Corrections to the Text

Revised Figure 4.9 Datapath in MARIE

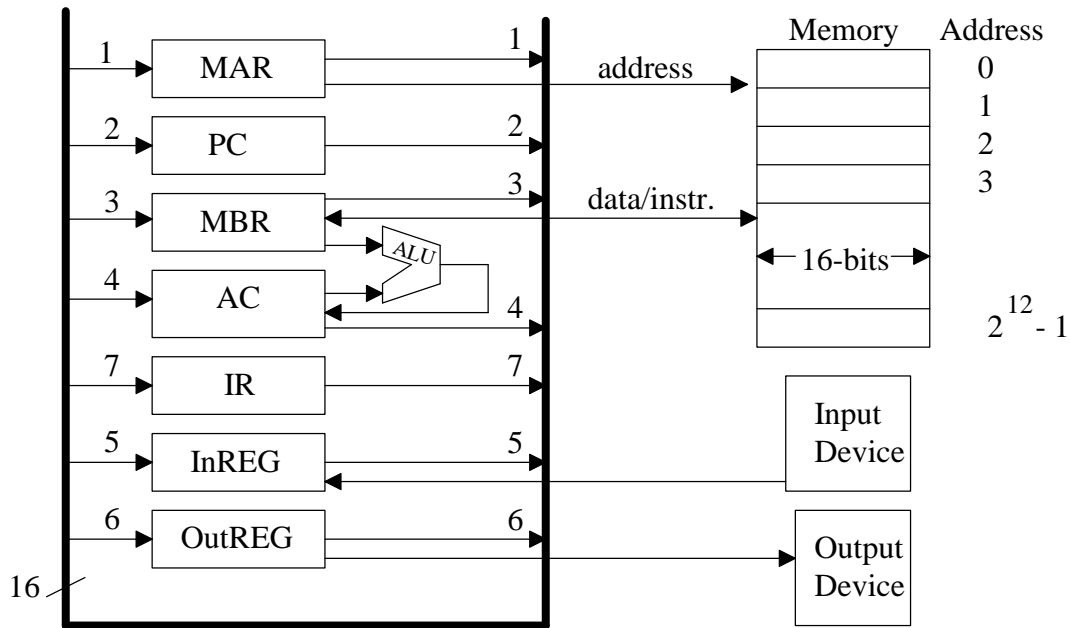
In Figure 4.9 (the datapath in MARIE) it bothers me that the data into and out of the Main Memory comes from the Bus and not the MBR. I would prefer the following figure:

Additionally, Figure 4.9 does NOT support the RTN of $PC \leftarrow PC + 1$, but that is a relatively minor issue.

Revised Figure 4.15 Connection of MARIE's MBR to Datapath

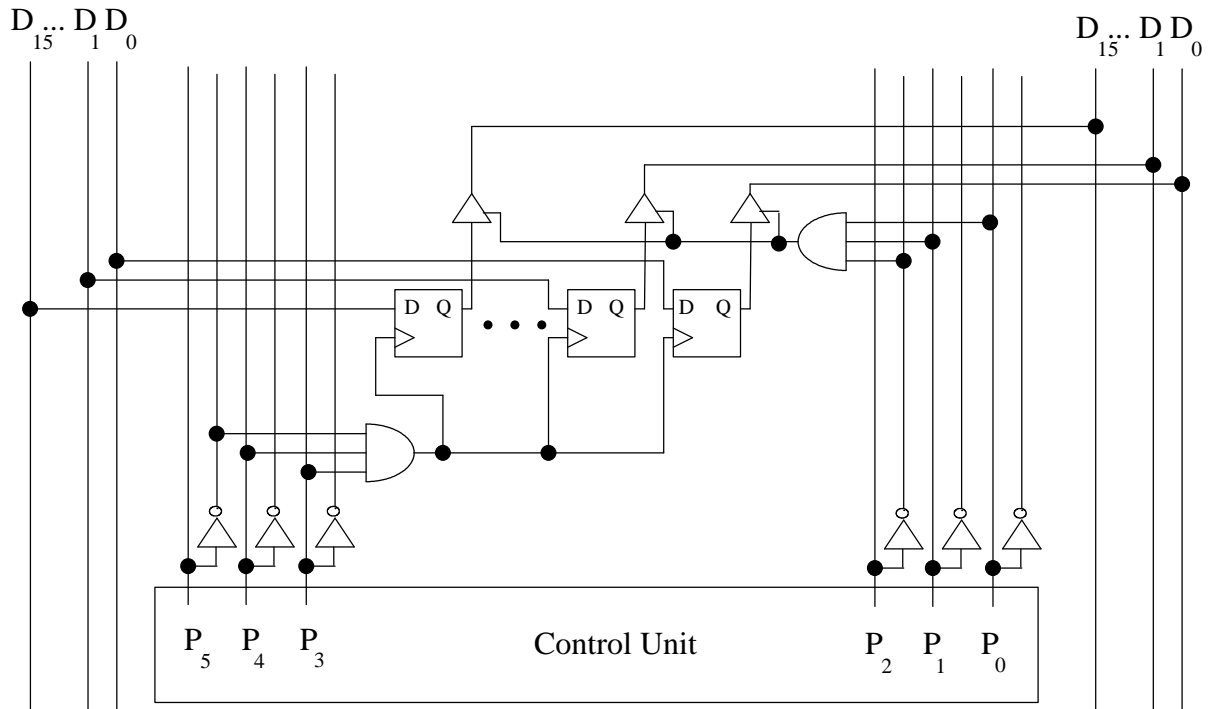
Figure 4.15 seems to have numerous mistakes, especially related to connections of Flip-Flops to the Bus (D_{15} - D_0). First, recall that seven registers are connected similarly to the Bus (D_{15} - D_0). When the (upper) AND gates from the MBR register are outputting to the bus, the remaining registers would be outputting 0 to the same wires causing the values to be garbled. Similarly, when storing to a different register (other than the MBR), the D-input of the FFs will all be 0. Thus, clearing its contents. A revised Figure 4.15 is as follows:
